REVISION n/a: THIS WARRANTY BULLETIN SUPERSEDES PREVIOUS VERSION.

BROKEN EXHAUST CLAMP AT TURBOCHARGER DIFFUSER PIPE 9700 (B13R)

MODEL YEAR(S) AND VEHICLE SERIAL NUMBERS (VIN) INVOLVED

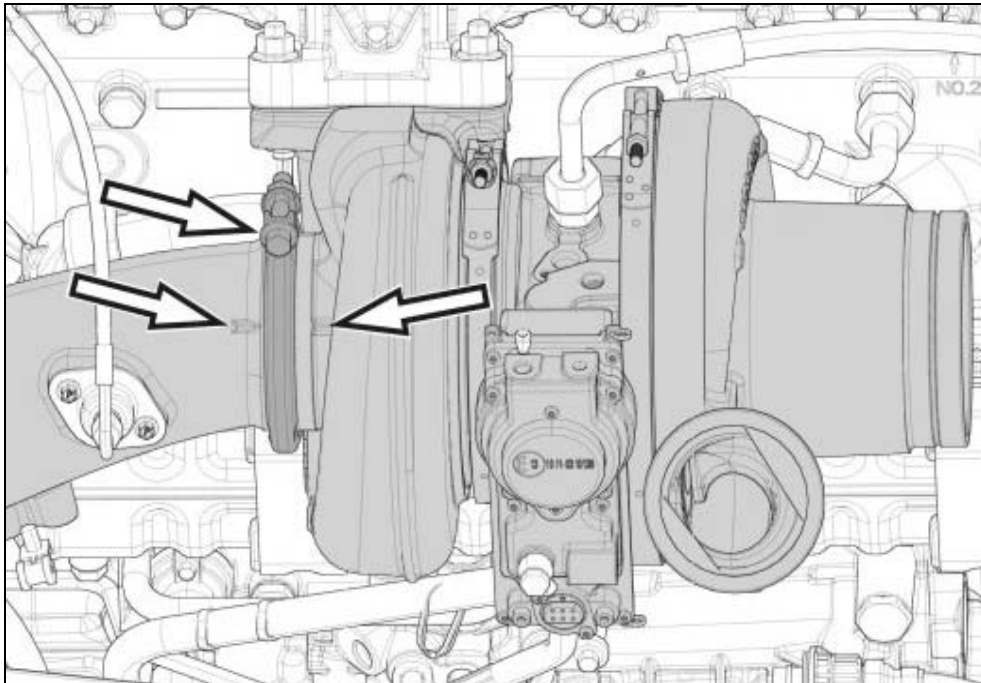
On the vehicles affected by this bulletin, the exhaust clamp with part number 20955220 gets broken and the turbocharger diffuser pipe may come out of the clamp which may cause the Automatic Fire Extinguishing System to discharge. For this reason, it is necessary to remove this clamp and replace it with clamp 21545619 as soon as possible.

- 1) Remove the radiator (refer to: Function group 26).
- 2) Replace the turbocharger outlet pipe V-band clamp. Use a new gasket between the diffuser and turbocharger. Turn the diffuser pipe to the correct position (see figure below). Tighten the clamp to the proper specification. **V-band clamps..... 10 ± 2 Nm (90 ± 9 in-lb)**

NOTE: WHEN POSITIONING THE DIFFUSER PIPE, ALIGN THE MATCH MARKS ON THE DIFFUSER AND ENGINE TURBOCHARGER, IF EQUIPPED
